VILLAGE OF MORTON GROVE
Zoning Board of Appeals
FLICKINGER MUNICIPAL CENTER
6101 Capulina Avenue, Morton Grove, IL 60053
January 20, 2020 - 7:00P.M.
AGENDA

Re: **ZBA 20-02 – 9131 New England Avenue**
Request for approval of an expansion of a principal structure on a lot with non-conforming area and width, and a request for waivers from Sections 12-4-2 and 12-2-6 to legalize a non-conforming side yard and driveway width, after the fact

STAFF REPORT

Proposed Front Elevation

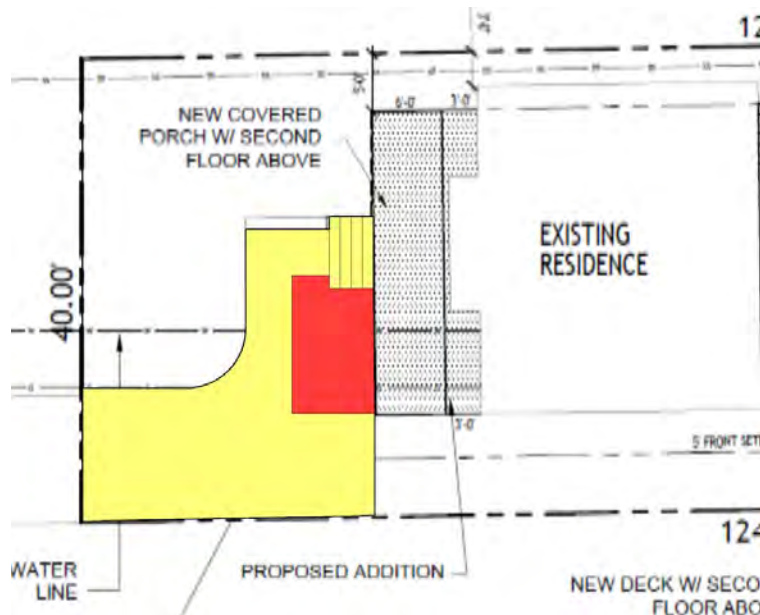
In accordance with Section 12-2-1:B.7, the applicant submitted a Design Workbook demonstrating that the project is compatible with the existing neighborhood. The applicant is proposing a white stucco facade with black windows and a dark standing seam metal roof. Other residences along the same blockface and in the surrounding one-block radius feature similar exterior details, including stucco finishes, all-white exteriors, and black windows. In accordance with Section 12-11-1:A.2, the applicant will also be required to submit a landscape plan to the Building Commissioner and Land Use Planner prior to the issuance of a building permit to demonstrate that proposed landscaping complies with the requirements of Chapter 12-11, Landscaping and Trees. Any changes to the building's exterior that are not compatible with the existing neighborhood and any landscape plan that does not meet the standards of Chapter 12-11 will require the applicant to obtain approval from the Appearance Commission.

Staff notes that the applicant originally proposed to extend the non-conforming north building wall east and west to provide aesthetic symmetry for the front elevation and to enable a larger expansion in building footprint. At the recommendation of staff, the applicant revised the building plans to make all dimensional aspects of the proposed addition conforming.

T1

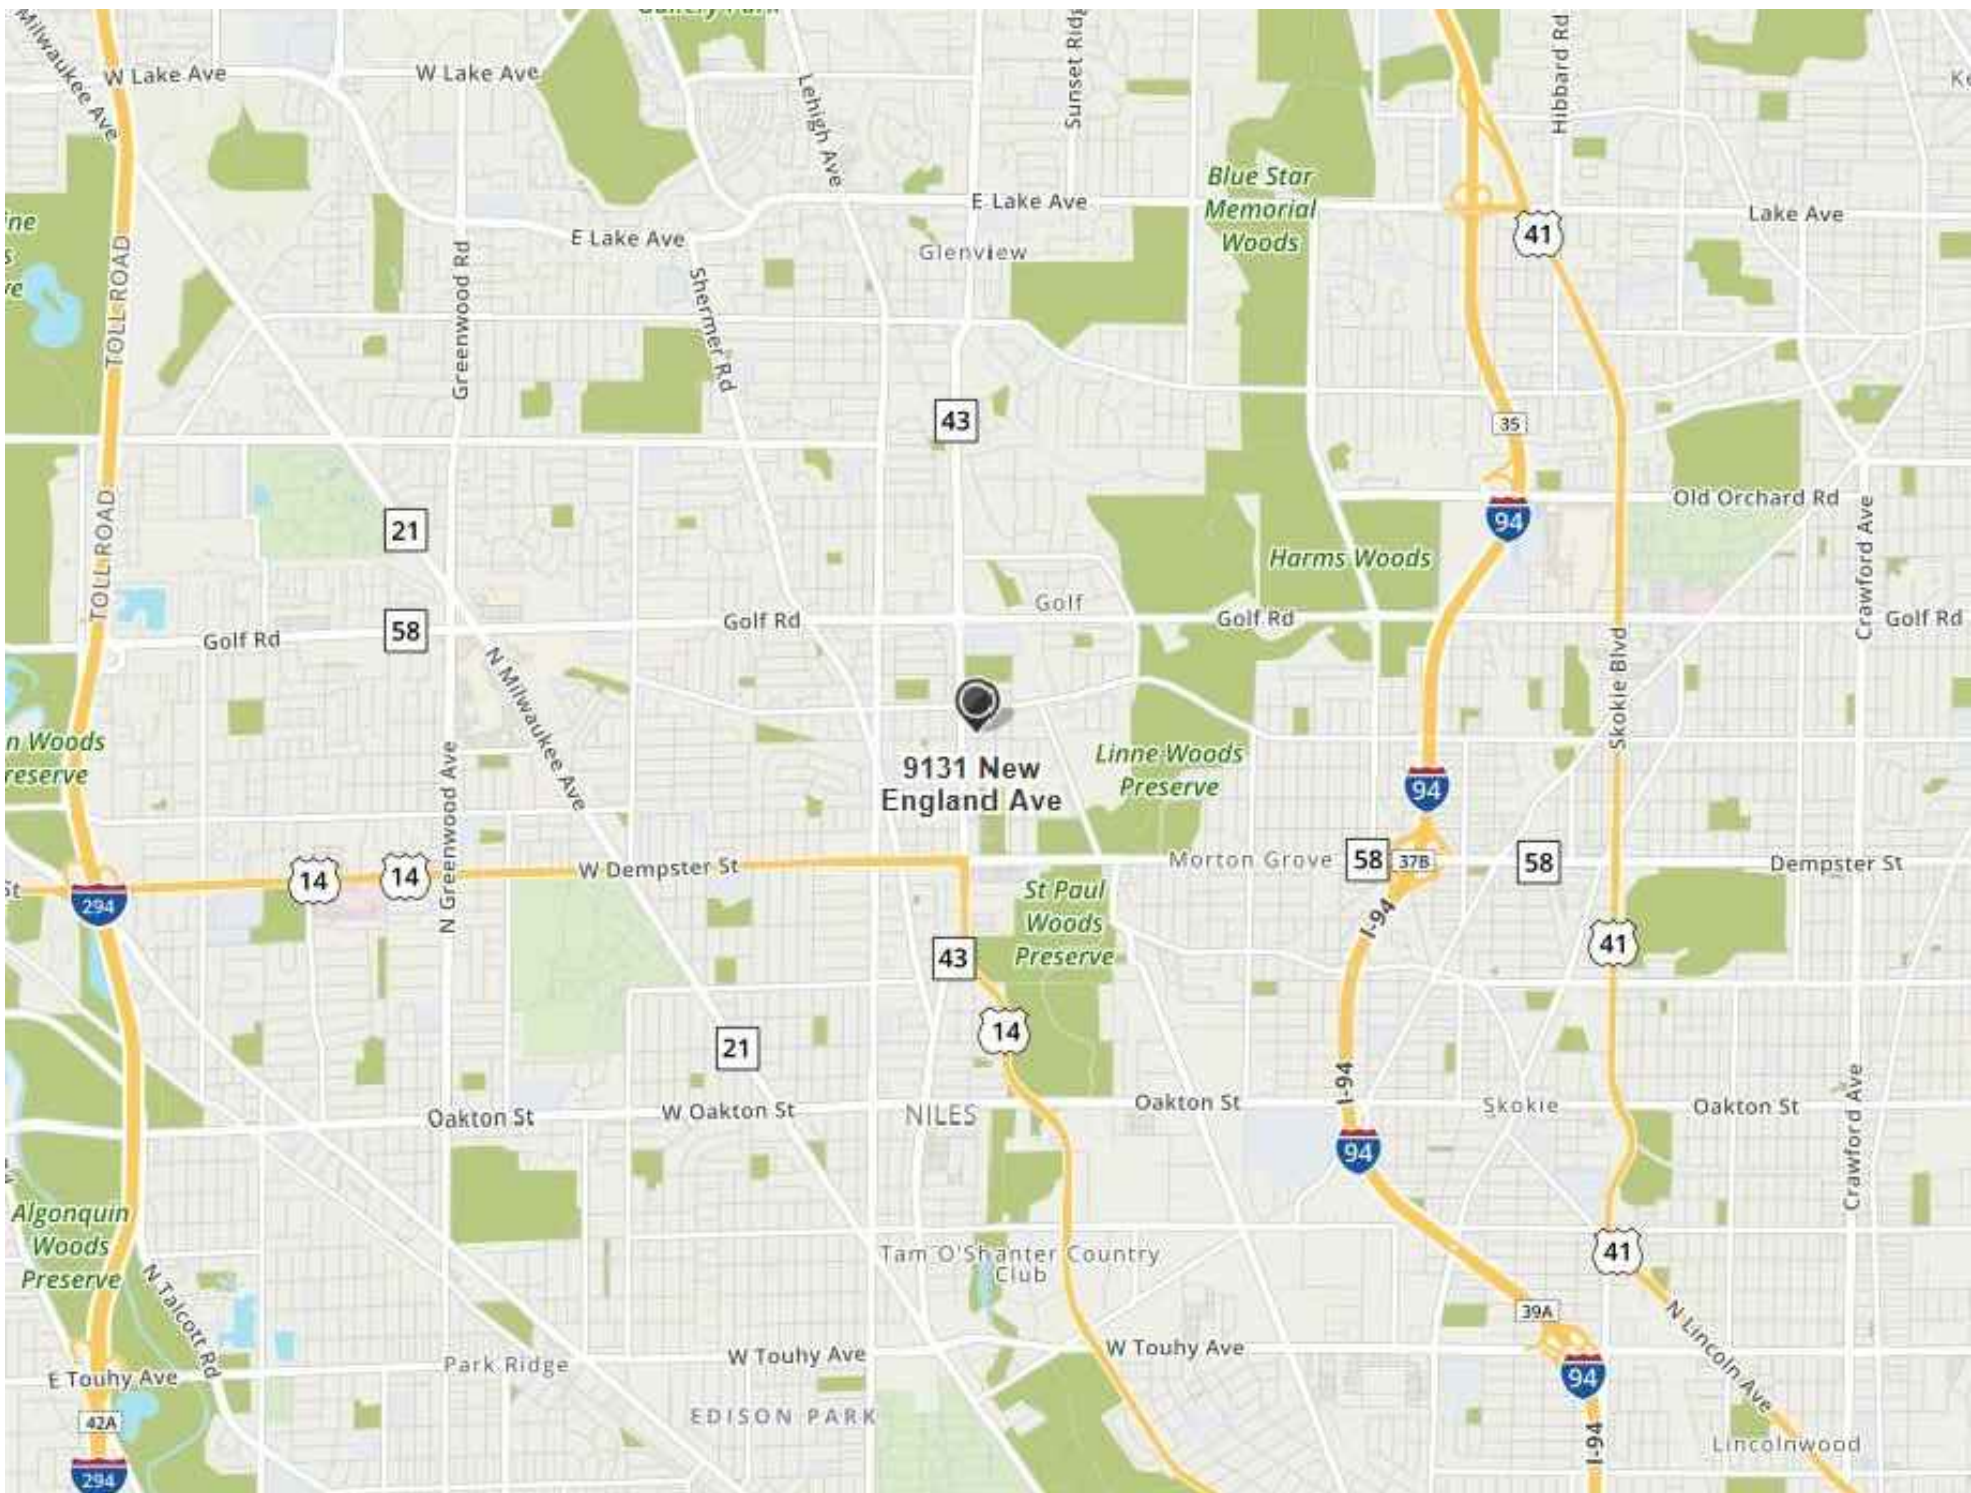
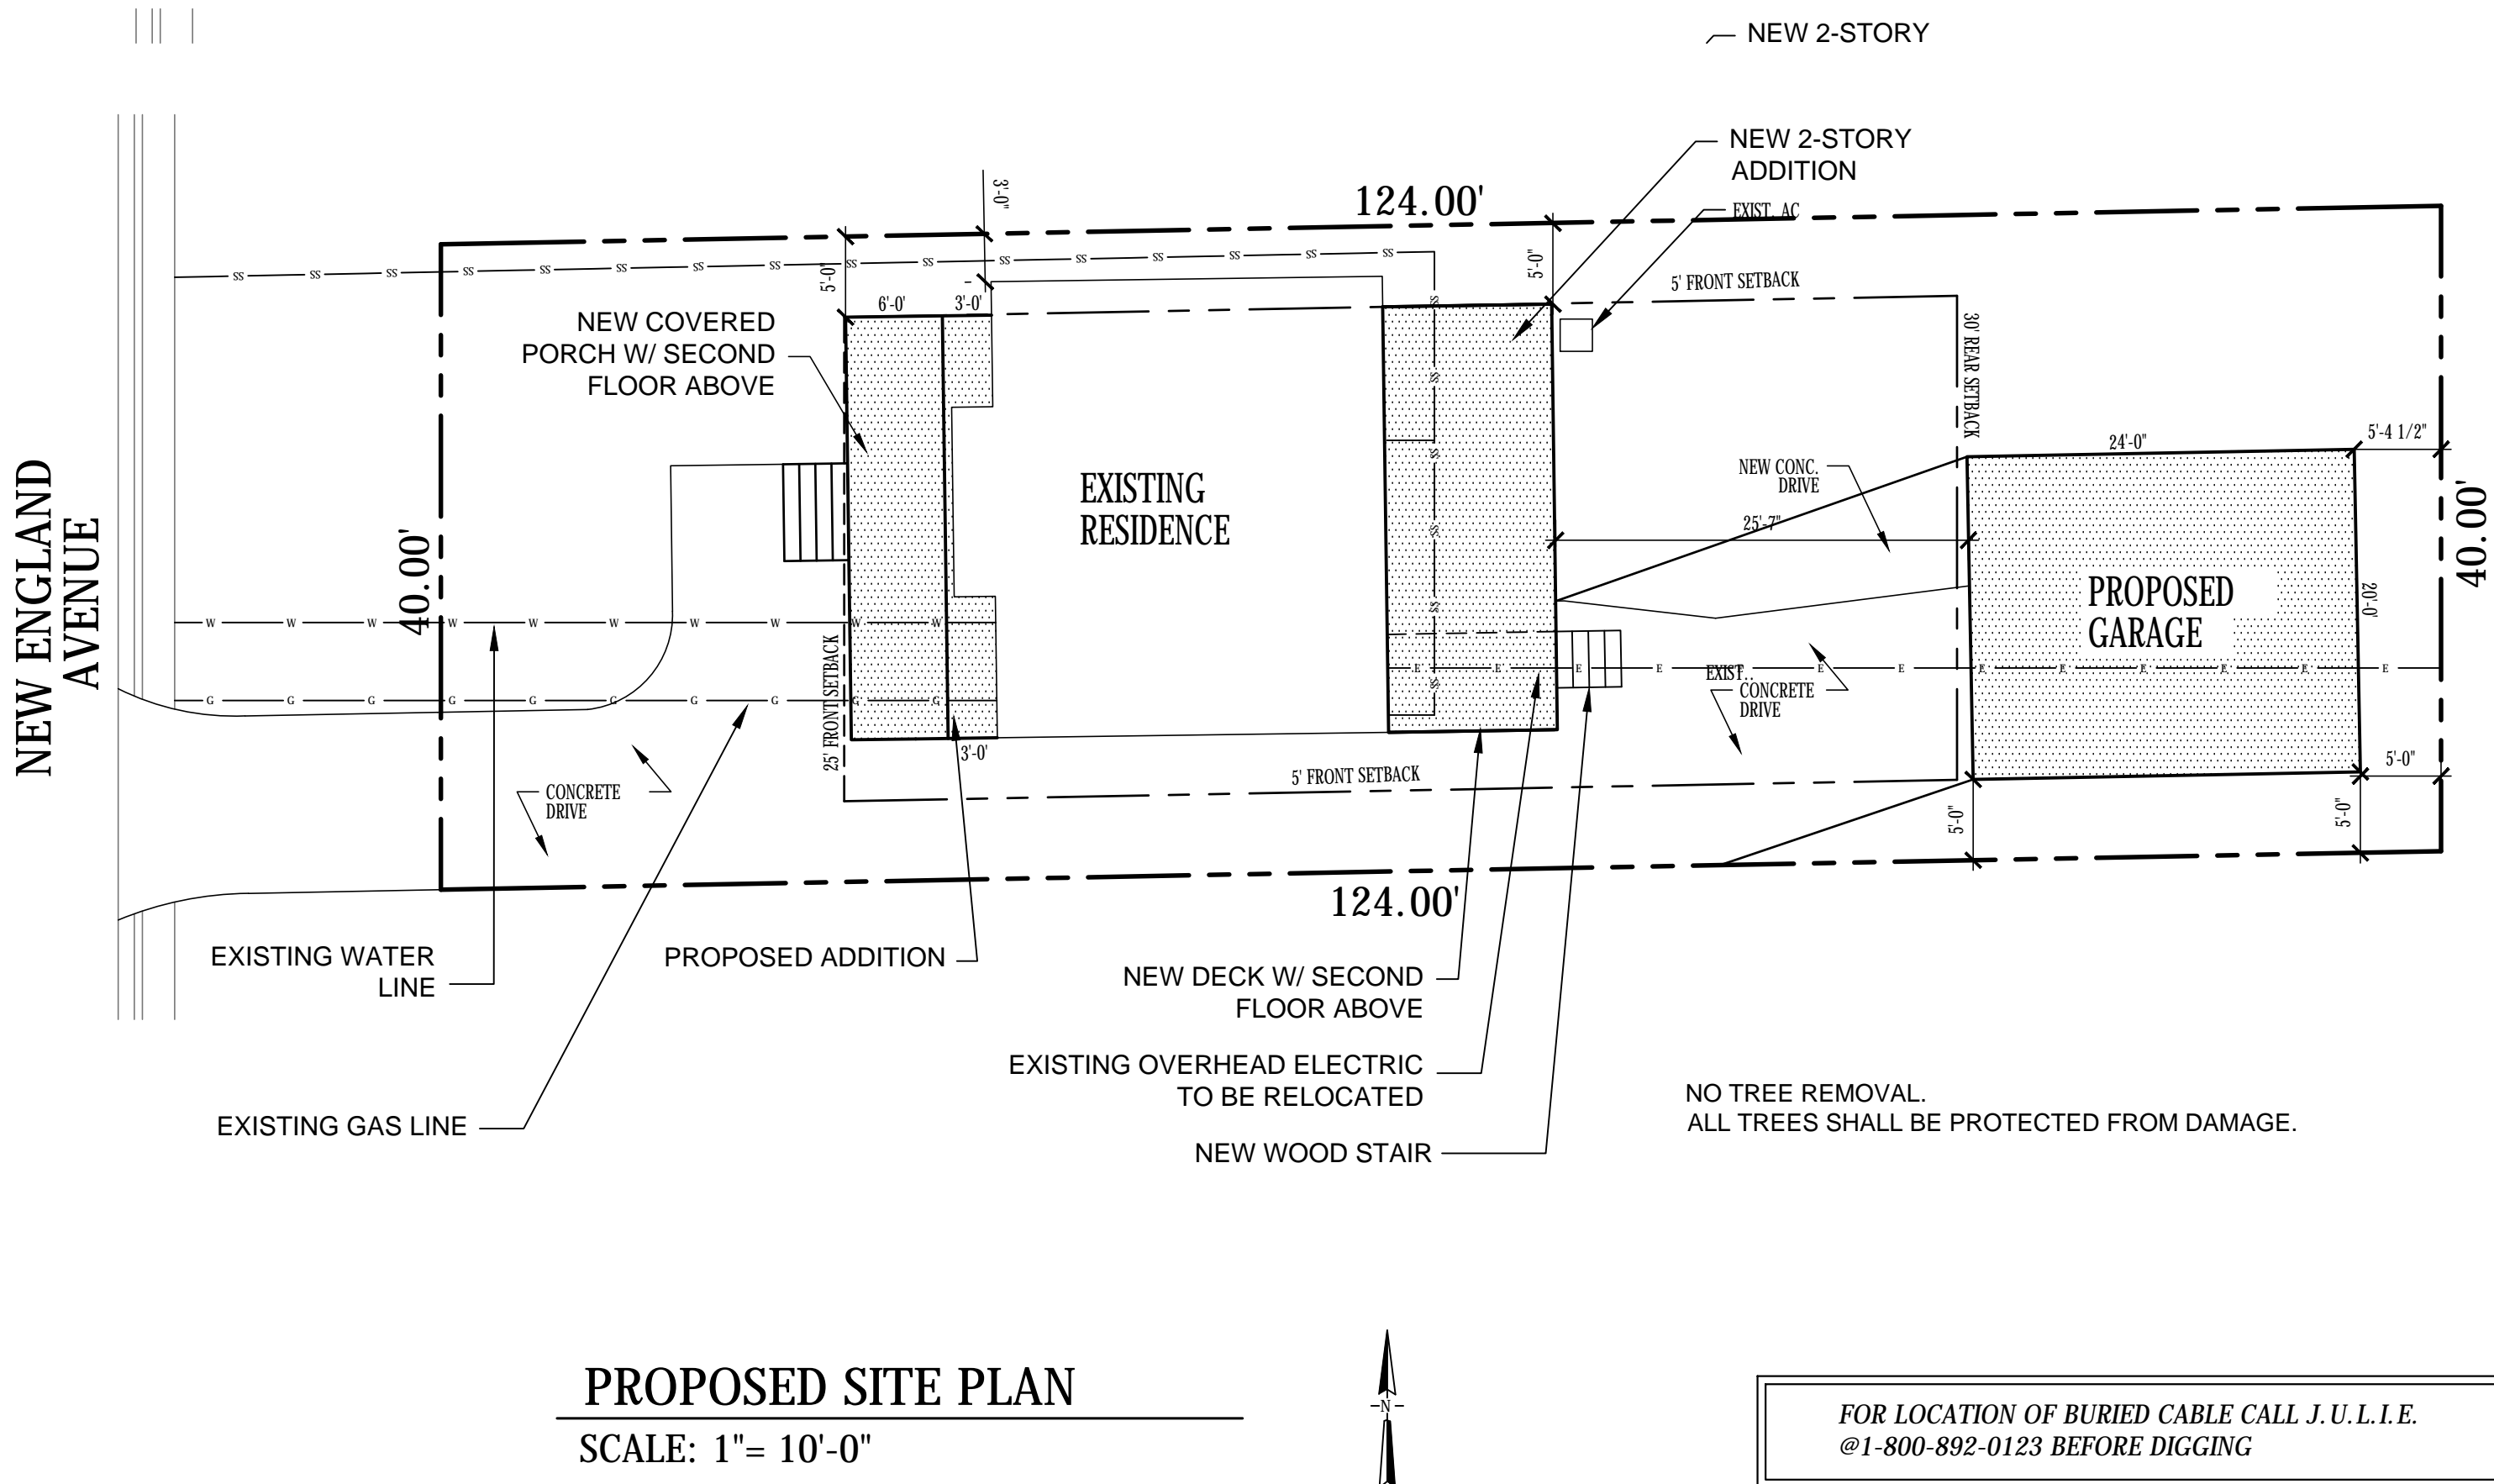
Staff's sole concern with the submitted site plan is the proposed concrete area located within the front yard. Per Section 12-2-6:G, sidewalks may be a maximum of 4 feet in width within the front yard. The applicant has agreed to reduce the width of the sidewalk within the front yard to no greater than 4 feet, which will result in a front yard plan similar to the one prepared by staff below. The yellow area illustrates where a compliant driveway and sidewalk may be placed. The red area illustrates the area of impermeable coverage that will need to be removed from the proposed plan to attain compliance. The final sidewalk design will be worked through in the formal building permitting process.

- 1) The proposed addition shall be built in accordance with the plans submitted by the applicant in the Variation Application dated 01/13/2020, except that the proposed walkway within the front yard shall comply with dimensional standards established in Section 12-2-6:G, Permitted Obstructions; and*
- 2) The applicant shall file all necessary plans and applications, for review and approval, and secure all necessary building permits prior to the commencement of construction.*
